RE: 13000 Wainwright Road, subdivision Perc Cert, amended comments

RE: 13000 Wainwright Road, subdivision Perc Cert, amended comments

OWNER:		PROJECT:	
EML MANAGEMENT, LLC 3 ASHCROFT WAY REISTERSTOWN, MARYLAND 21136		13000 WAINWRIGHT ROAD	
LOCATION:		THE MAP-40-000-15 PARCELS-42 HOWARD COUNTY, MARYLAND	
TITLE:		REVISED PERCOLATION CERTIFICATION PLAN	
DATE:		JUNE 2023	
PROJECT NO. 2485		DRAWING NO. 1 OF 1	
DESIGN: CHA/JCO	DRAFT: JCO	SCALE: AS SHOWN

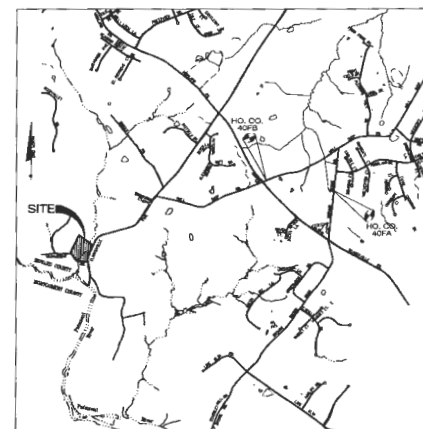
1. A small portion of the proposed septic reserve area (near perc test #3) on proposed 'Lot 1' is within 25 feet of slopes > 25%.
2. Delete Note #6.
3. Add this Note:

All wells shall be drilled prior to final plat recordation. It is the developer's responsibility to schedule the well drilling prior to final plat submission. It will not be considered "government delay" if the well drilling holds up Health Department signature of the Record Plat.
4. Edit Note #8 as follows

Existing wells, septic systems, and sewage disposal areas within 100' of the property and those wells within 200' down-gradient of existing or proposed septic systems or sewage disposal areas have been shown. Any septic system drainfield or septic reserve area within 200 feet up-gradient of proposed wells or wellboxes are shown.
5. Edit Note #9 as follows:

The purpose of this plan is to revise a previously approved percolation certification plan (7/16/98) by changing proposed lot lines, relocating a Use-In –Common (re: Ingress/Egress) Easement, and adding alternate wells and wellbox locations.
6. Edit Note #11 as follows (supercedes May 29 comment):

The existing drilled well (HO-94-0210) on proposed 'Lot 2' is to be sealed by a Licensed Well Driller, and the Well Abandonment Report received by the Health Department, prior to Record Plat submittal.
7. Add this Note:

The pit well in front of the existing house (identified as "Abandoned Well") on proposed 'Lot 2' is to be sealed by a Licensed Well Driller, and the Well Abandonment Report received by the Health Department, prior to Record Plat submittal.

8. Edit Note #12 as follows (supercedes May 29 comment):
The septic system serving the existing residence on proposed 'Lot 2' is to be abandoned and replaced prior to Record Plat submittal. Photos and a contractors report will be submitted to the Health Department showing and indicating proper abandonment of the existing septic tank and the existing dry well.

9. On proposed 'Lot 2', there is a structure about 45 feet long identified as "Ex. Structure To Be Removed". Correctly identify this structure as a : "Semi-truck trailer To Be Removed".

10. There are two auxiliary structures near the existing house on [proposed 'Lot 2'. Locate these two structures on the plan and identify whether what each is and whether it is 'To Remain' or 'To Be Removed'.

11. There is a utility easement crossing the subject property in the area proposed as 'Lot 2' and 'Lot 3'. Show the location of the utility easement and the location of the utility pole and the overhead electric line within the easement. Observe that neither a well location not the septic reserve area may occupy the same area as the utility easement.

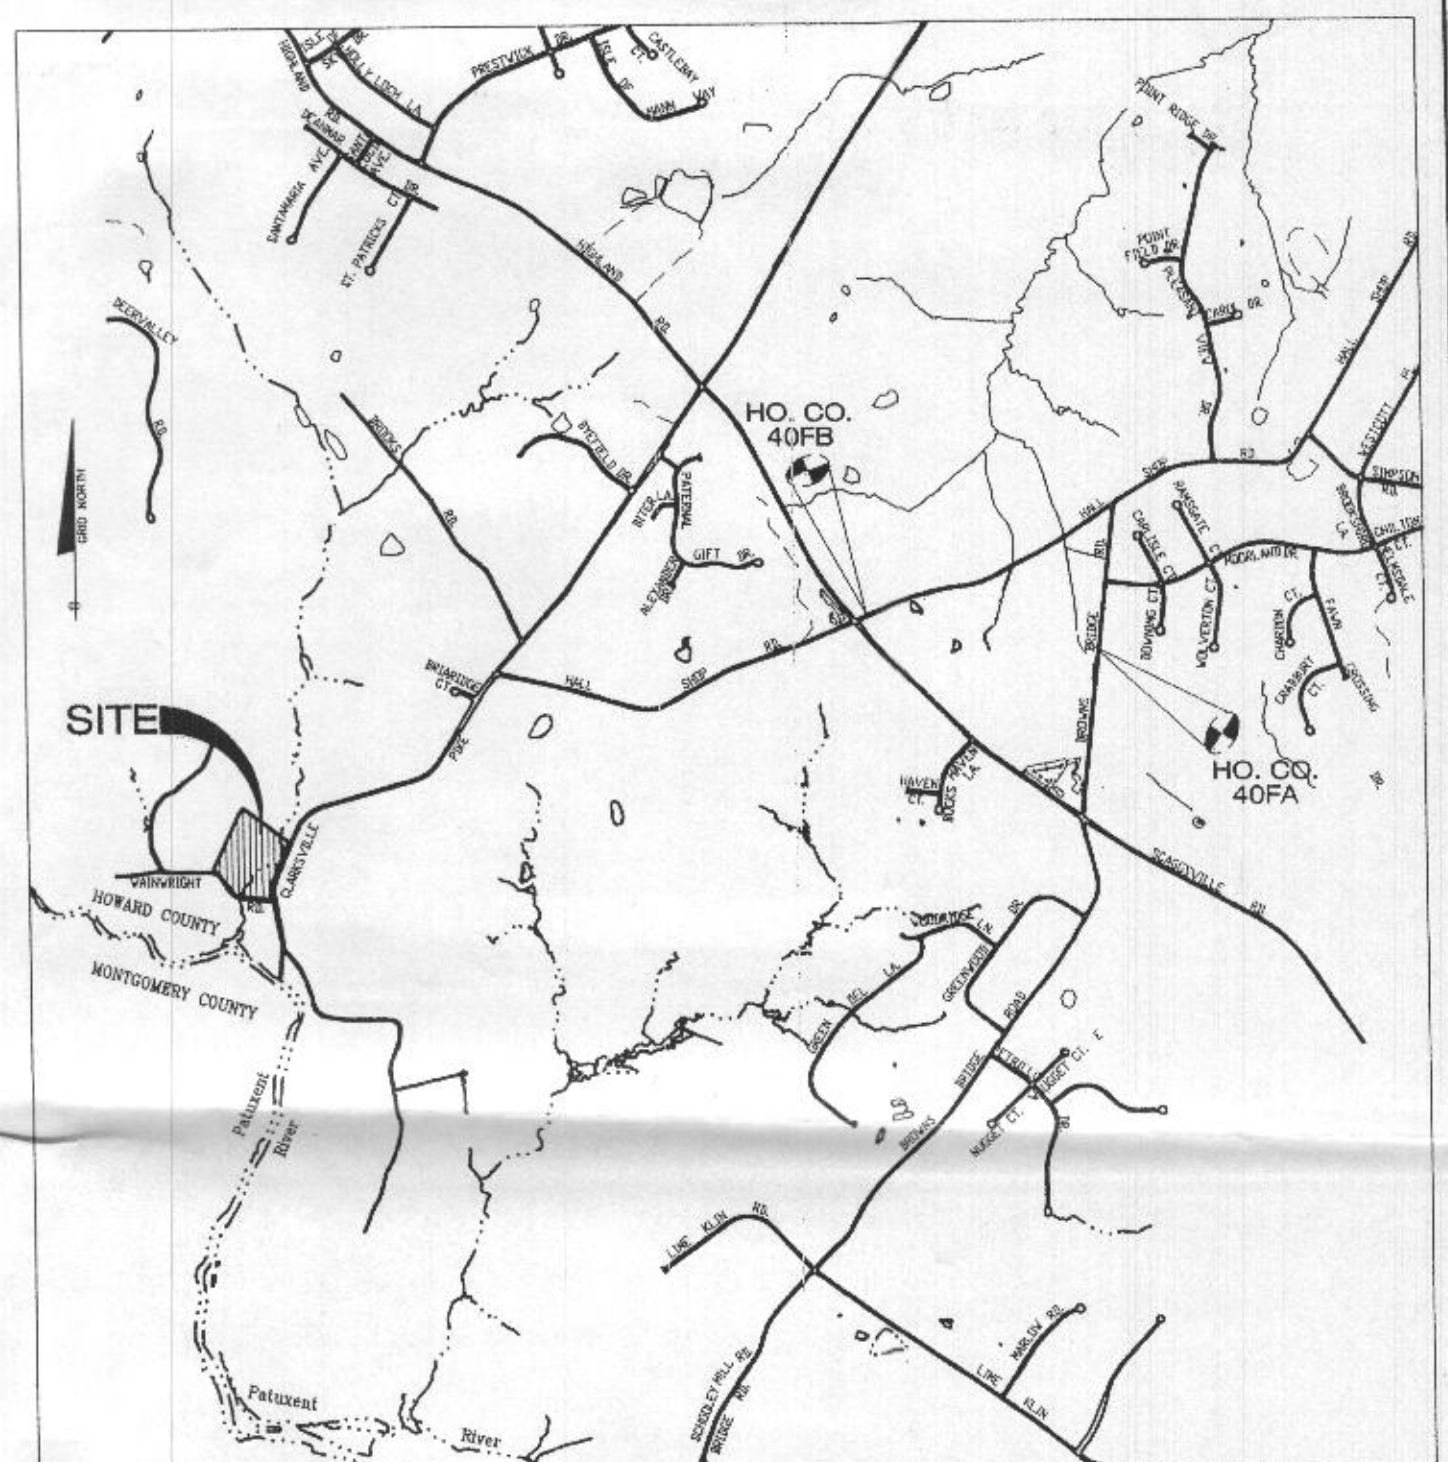
1. There are small unusable triangles at the 'top' and 'bottom' of the proposed septic reserve on Lot 1. It appears that these can be deleted and the lower boundary of the septic reserve 'squared off' the contour.
2. Similarly on Lot 2, delete the small unusable triangles and extend the septic reserve on contour to the southwest to make up the lost area.
3. On Lot 2, move 'Well #2' to the east a little so that it is not in the drainageway.
4. On Lot 2 add the phrase "To Be Sealed" to the label describing Approx. Abandoned Well, and insert the term "Pit" in the label (as it is a pit well).
5. Correct the label for Approx. Existing Well by replacing the term 'Abandoned' with the term "Sealed".
